DOWNTOWN MAIN STREET RECONSTRUCTION TASK FORCE AGENDA

MEMO

TO: Downtown Main Street Construction Task Force Members
FROM: Andrew Beyer, P.E.
DATE: March 19, 2024
RE: Downtown Main Street Construction Task Force Meeting of March 27, 2024

Review and take possible action: Downtown Main Street bump out locations

5

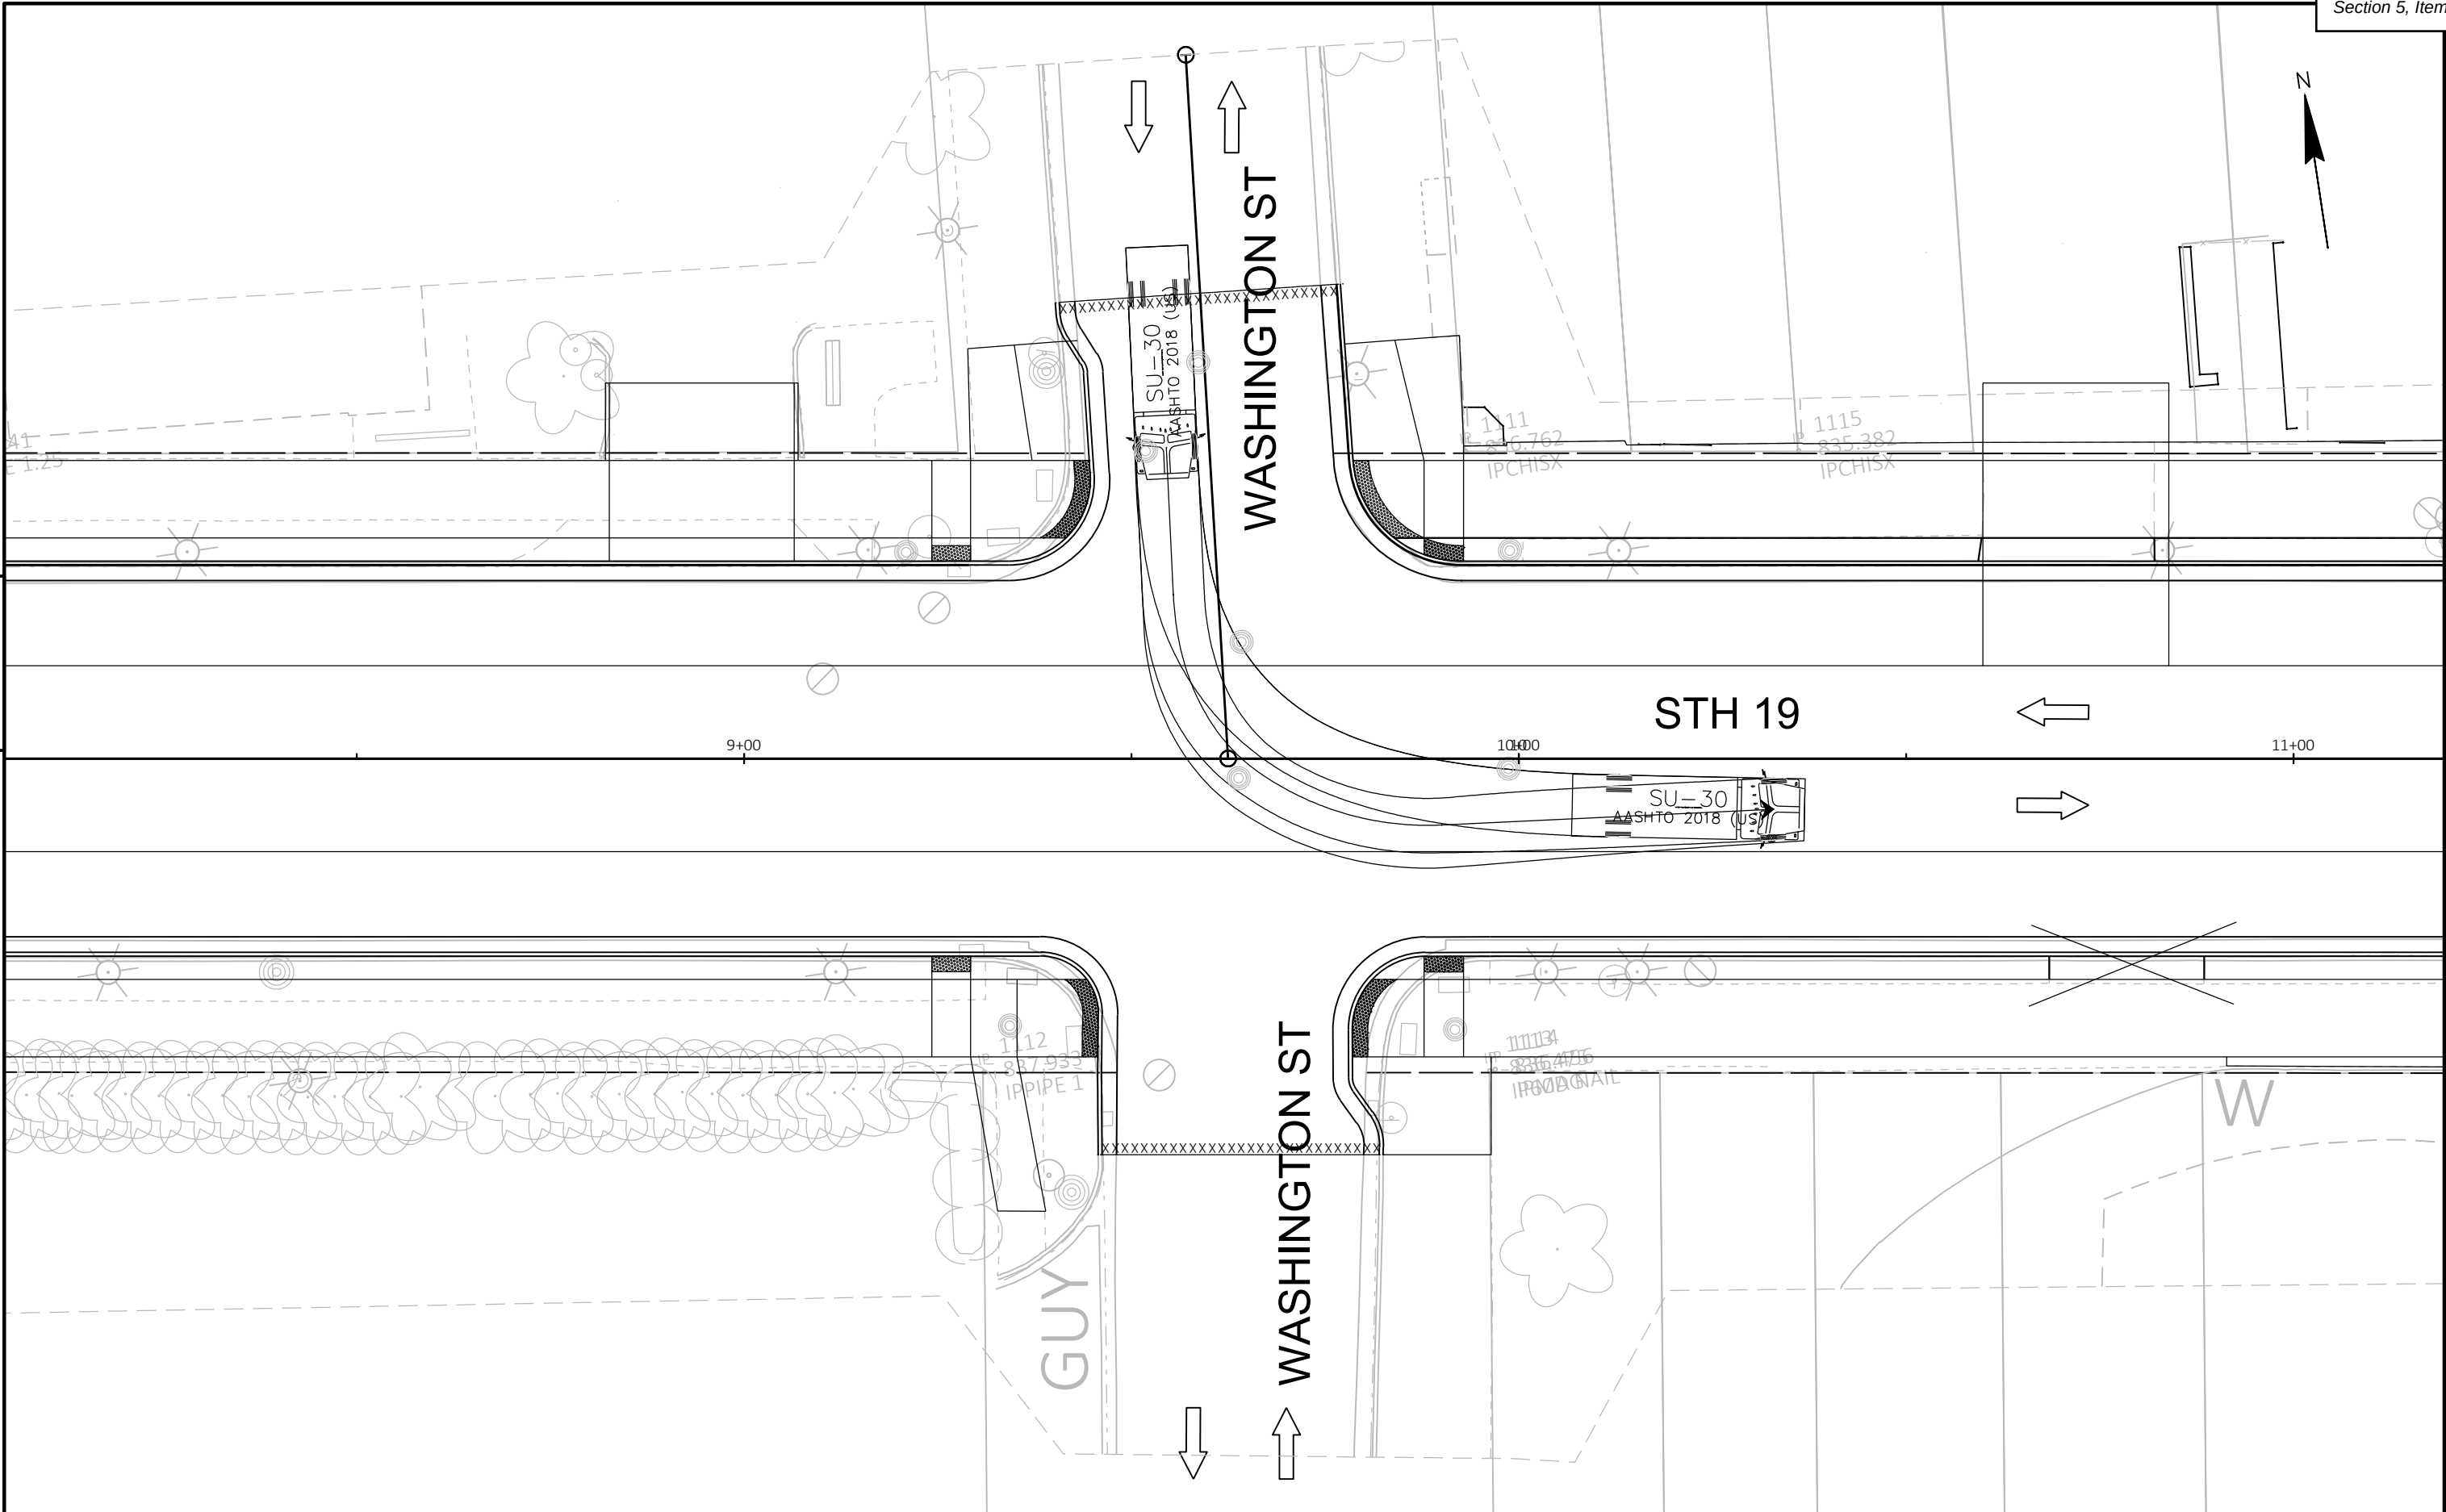
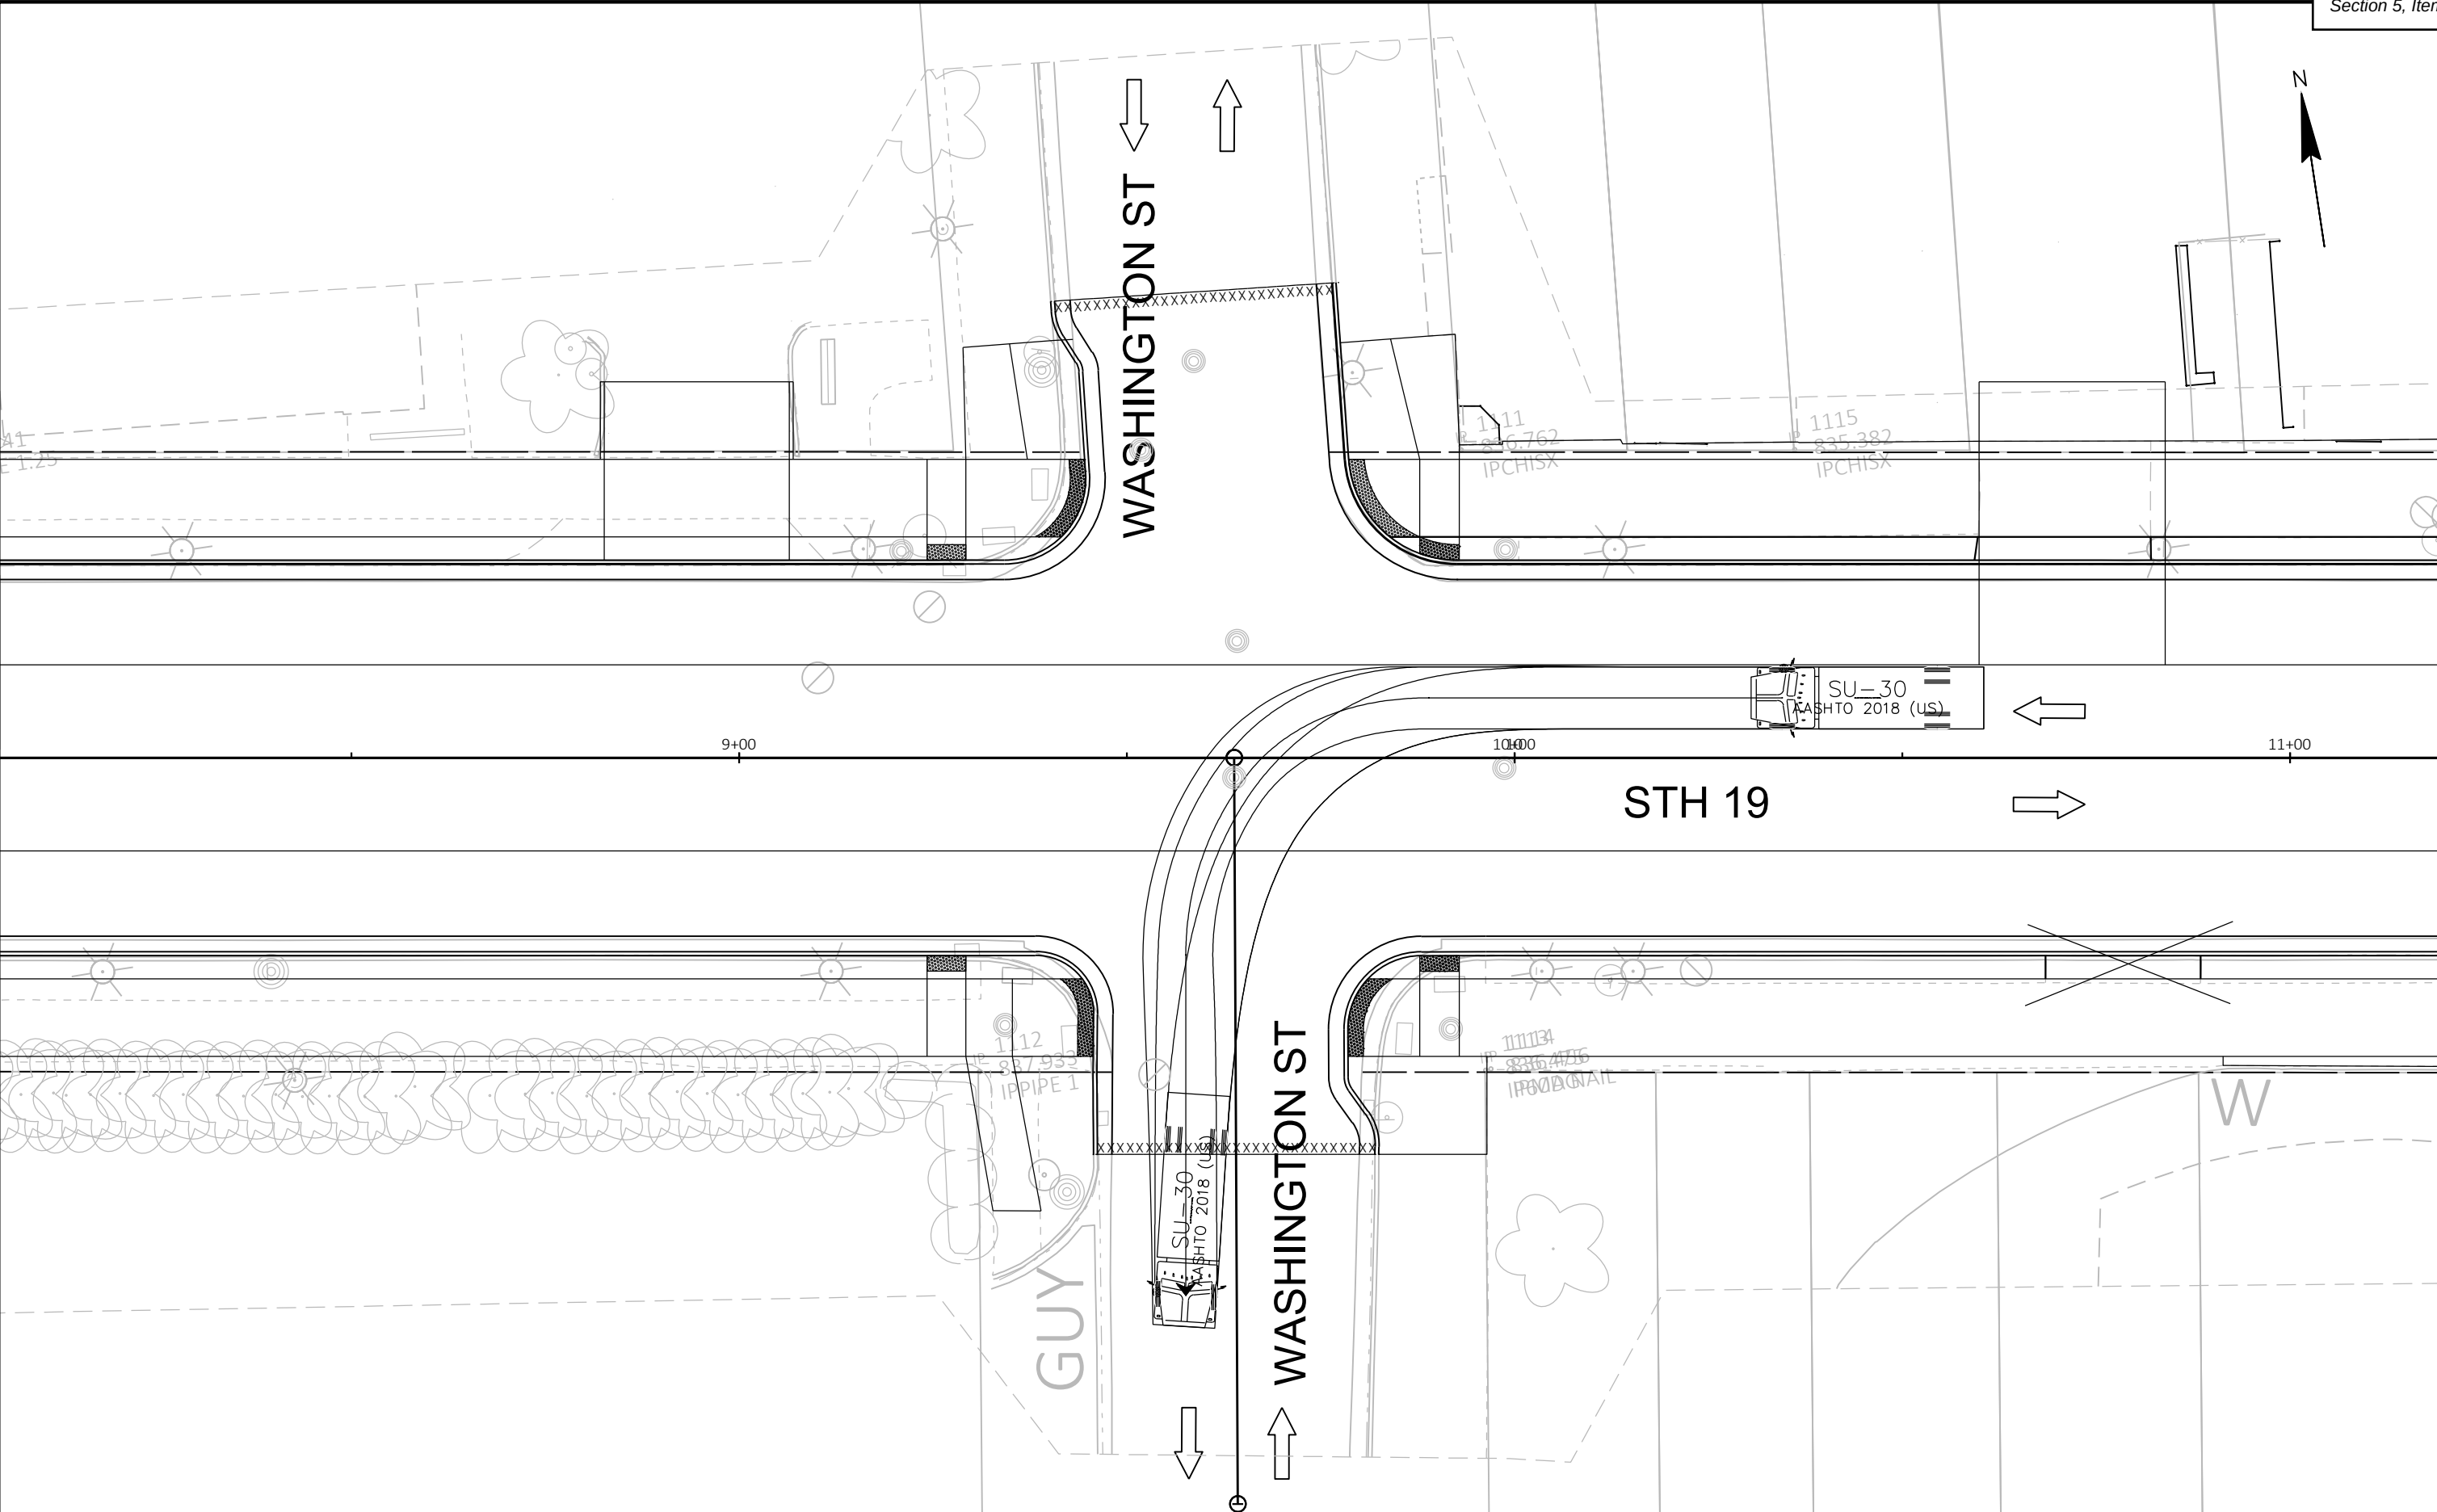
City of Watertown staff recently convened with Wisconsin Department of Transportation (WisDOT) representatives to assess proposed bump out locations for the Downtown Main Street Reconstruction Project spanning from Church Street to Market Street. The collaboration involved a detailed examination by the WisDOT design team of the bump out sizes and locations outlined in the Watertown Downtown Vision & Main Street Reconstruction Plan, particularly in regard to accommodating truck turning radii.

Following this review, it was determined that several bump outs identified in the plan require size reduction or elimination to ensure safe truck maneuvering onto and off of Main Street. Attached are plan sheets provided by the WisDOT design team, which illustrate the proposed changes for discussion.

WisDOT has solicited feedback from the City regarding the inclusion of smaller bump outs, e.g. on N. Fifth Street, or the elimination of minor bump outs from the plans.

- State said that a few of the intersections bump outs were reduced to 1' to 2' and the City may want to consider eliminating them as well as there would not be much of a benefit.

- State to provide markup identifying these locations to the City.
 - City will review and make decision if these should be eliminated as well.
- Handicap parking spot by the kiosk or mid block bump out?
